Piper Aircraft Corporation

SERVICE LETTER

No-643

Control Shaft Collar Restraining Strap

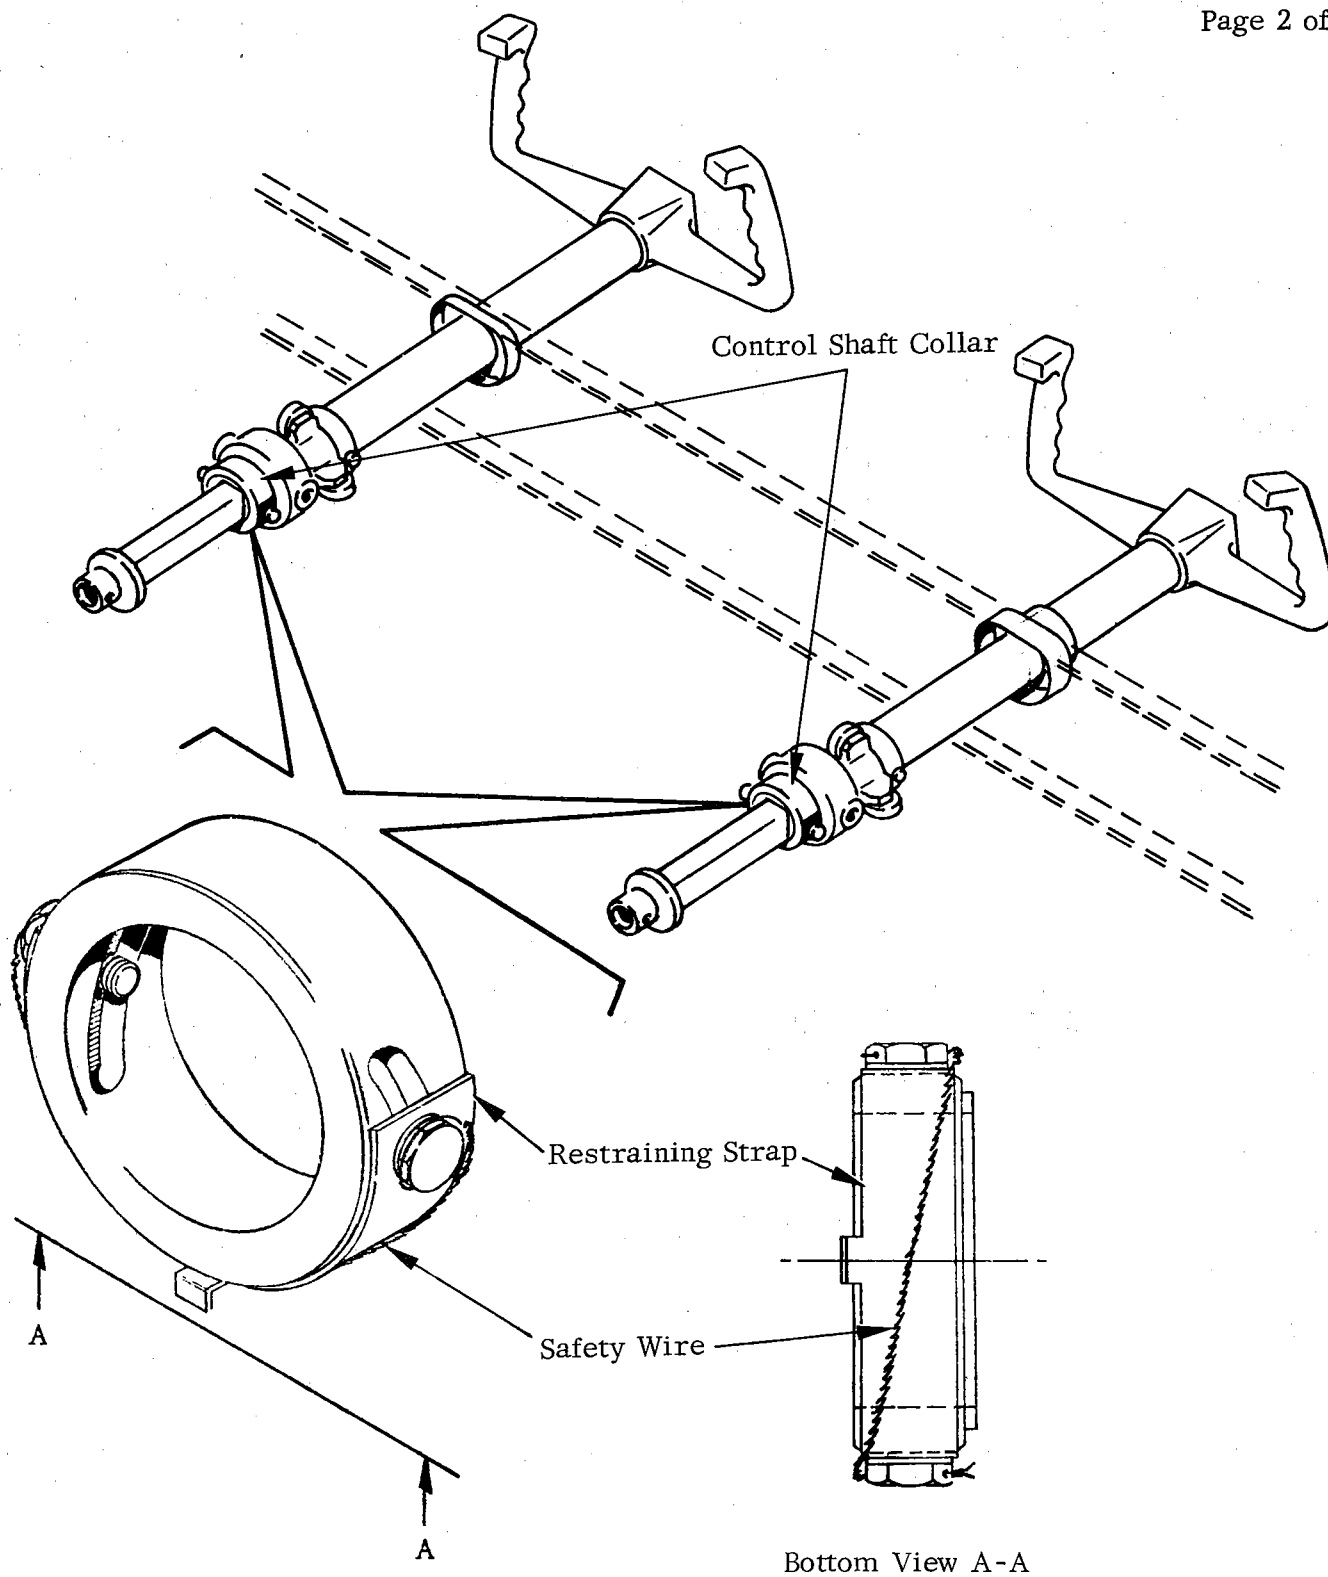
A recent field report has indicated the need for the addition of a safety wire restraining strap and a revised safety wiring method regarding the attachment of the control shaft collar to the control shaft tube assembly.

This service release provides material and instructions for the installation of a safety wire restraining strap and to revise the control shaft collar safety wiring (refer to sketch on reverse side of this Service Letter for a general illustration).

Contained in Piper Part No. 760 723, Control Shaft Collar Restraining Strap Installation Kit.

One (1) each (per aircraft) Piper Part No. 760 723, Control Shaft Collar Restraining Strap Installation Kit.
